Device	XC886/888CLM Series
Marking/Step	AA
Package	PG-TQFP-48/64

This Errata Sheet describes the deviations from the current user documentation. The module oriented classification and numbering system uses an ascending sequence over several derivatives, including already solved deviations. So gaps inside this enumeration can occur.

Table 1 Current Documentation

Figure 2

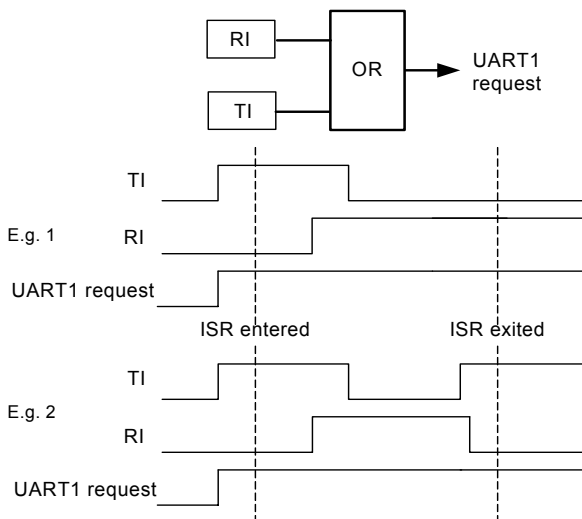
The problem is that it may occur at some point in the application, that any new UART1 interrupt request can no longer be detected after a return-from-interrupt (reti) due to service of earlier event(s). This happens when the following conditions are true:

1. UART1 events are serviced by interrupt (i.e. flags are checked and cleared only in the interrupt routine ISR),
2. Either RI or TI is set at any one time throughout the ISR (even while the other is cleared) such that at least one of the flags is still set after reti, causing the UART1 request line, which is an OR-function of the two flags RI and TI, to remain set throughout the ISR and after reti.

Two example scenerios are illustrated in the following figure:

This means, any future UART1 RI or TI event is not able to cause a rising edge and therefore not able to trigger an interrupt request to the core – as if the UART1 interrupts had been disabled, until both RI and TI flags are cleared at some time. The clearing of flags would have to be done by user's code

There are two suggested workaround:

1. If other events of interrupt node XINTR8 (EX2) need not be enabled for interrupt, disable this interrupt node and use software polling of the flags instead.
2. Before return from interrupt, check again if RI or TI is (still) set (due to new request since the last check). If so, jump and execute the ISR routine from start. Exit only when all flags are checked to be cleared. However, dummy interrupt of the node may occur after return from interrupt, and should be ignored. Another drawback is if UART1 events are occurring at high rate, the CPU may be 'stuck' in the service routine of the UART1 interrupt for a long time.

Figure 4 FIFO structure

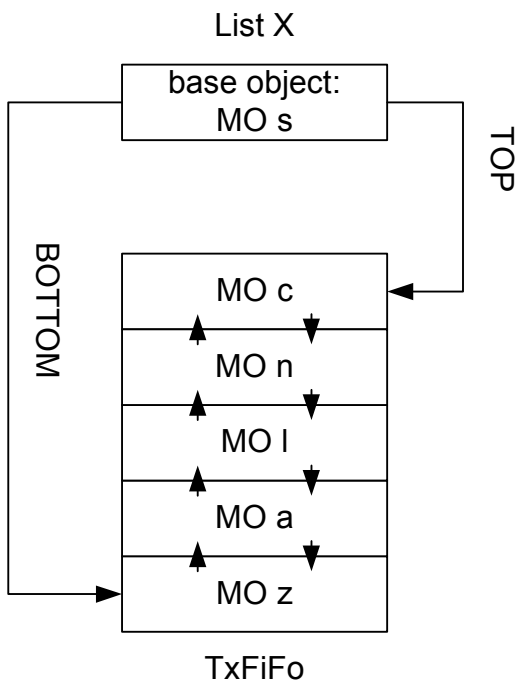
A Tx FIFO overflow interrupt will not be generated after the transmission of the Tx FIFO base object.

If Tx FIFO overflow interrupt needed, take the FIFO base object out of the circular list of the Tx message objects. That is to say, just use the FIFO base object for FIFO control, but not to store a Tx message.

Figure 6 Counting sequence of T12 in center-aligned mode

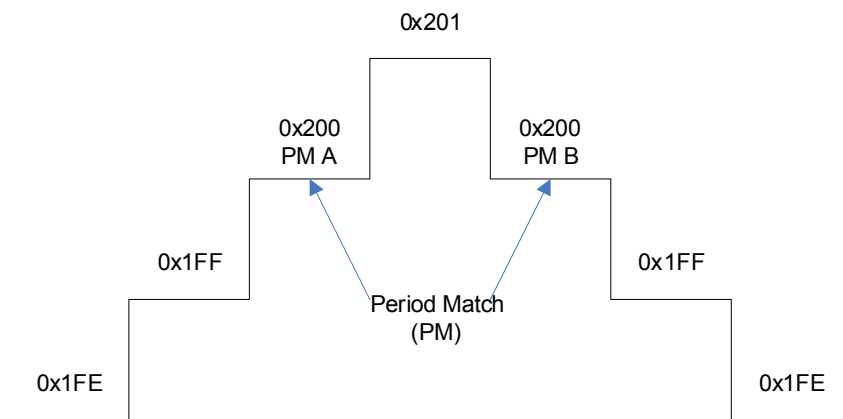
After detecting a period match (PM A) in centre-aligned mode, T12 counts down from PM + 1 as shown below:

This means a second PM event (PM B) will occur during the counting down. If ADC is triggered externally via ETRx2 (T12PM), it will be triggered twice in succession. Depending on how real-time the application code is running as well as the T12 count rate and ADC conversion rate, the application could observe two ADC interrupts - once at PM A and once at PM B.

To avoid triggering twice the ADC interrupts, it is suggested to use ETRx6 from multi-channel mode instead of ETRx2 as the trigger source for ADC. Additional initialization are as follows:

Figure 7

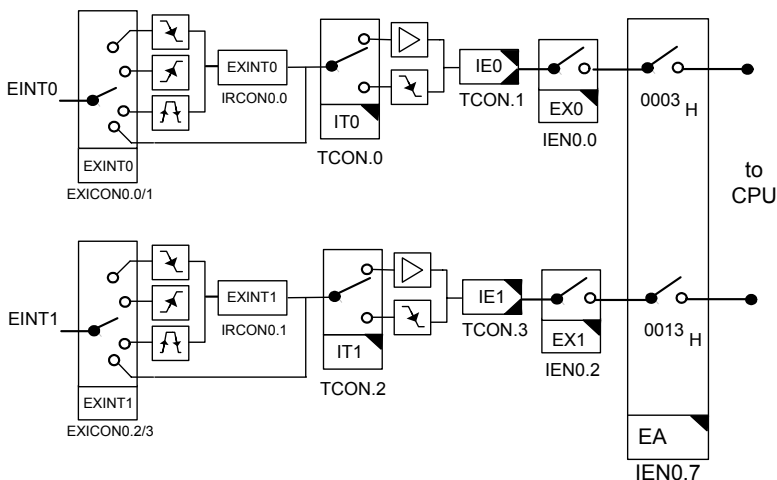
External interrupt 0 and 1 may individually be selected via respective bits (`EXINTx`) in `EXICON0` register, to request interrupt on falling edge, rising edge, both edges or to bypass the edge detection.

Edge detection is done in the system unit. If enabled, an active event will set the `EXINTx` flag and correspondingly set the `IEx` flag in `TCON`. It should be noted that after any external interrupt `x` event, flag `EXINTx` must be cleared. In case of falling edge as active event, this allows any future active event to be able to set the flag `IEx` as interrupt request. In case of low level as active event, this prevents unintended recurring triggering of interrupt request.

Figure 8

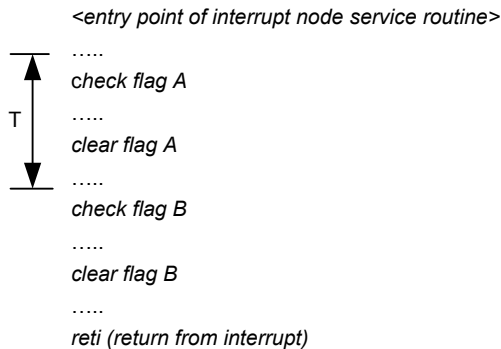
It might occur in the application, that sometimes NMI interrupt requests are serviced, but no active NMI interrupt flags are found.

Consider the following NMI interrupt service routine pseudo-code, and scenario where a NMI interrupt source A event leads to interrupt request of the NMI node and CPU vectors to the NMI interrupt routine. Meanwhile, NMI interrupt source B and its flag becomes active any time in the duration indicated by T:

In this case, NMI flag B will be cleared as a standard procedure by the NMI interrupt routine in the current service. However, the pending interrupt request for the NMI node remains activated after RETI, as it is only cleared by hardware when CPU acknowledge the NMI interrupt and vectors to the NMI service routine.

Figure 9

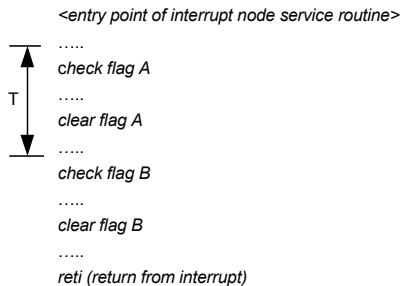
Consider the case where an enabled interrupt node is shared by more than 2 events, and where at least two of the events (A and B) are enabled for interrupt while at least one event (C) is not enabled for interrupt. In this case, flag C is one of the flags listed in above table.

While the interrupt routine is already running due to event A having occurred, event B and C occurs any time in the duration indicated by T:

This sets the pending interrupt request while flag B is set. Although event B is serviced and flag B is cleared in the following service routine, on return from interrupt, the pending interrupt request remains activated. This is because event C is not enabled for interrupt (and therefore flag C is neither checked nor cleared in the interrupt routine) while flag C is not qualified. This leads to following servicing of the interrupt node again, but potentially no active flag is found, i.e. dummy interrupt service. To prevent such dummy interrupt vectoring on the above listed interrupt nodes, do not use mixed interrupt servicing and polling scheme, i.e. enable all events of the node for interrupt if interrupt node is enabled. Otherwise if mixed interrupt servicing and polling scheme is to be used, ignore these dummy interrupt vectoring.

Figure 10 Loss of Arbitration

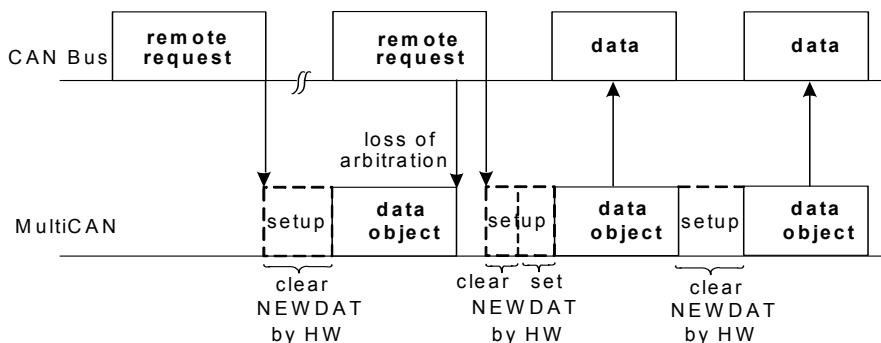
When the appropriate message object (data frame) triggered by the first remote frame wins the arbitration, it will be sent out and `NEWDAT` is not reset. This leads to an additional data frame, that will be sent by this message object (clearing `NEWDAT`).

There will, however, not be more data frames than there are corresponding remote requests.
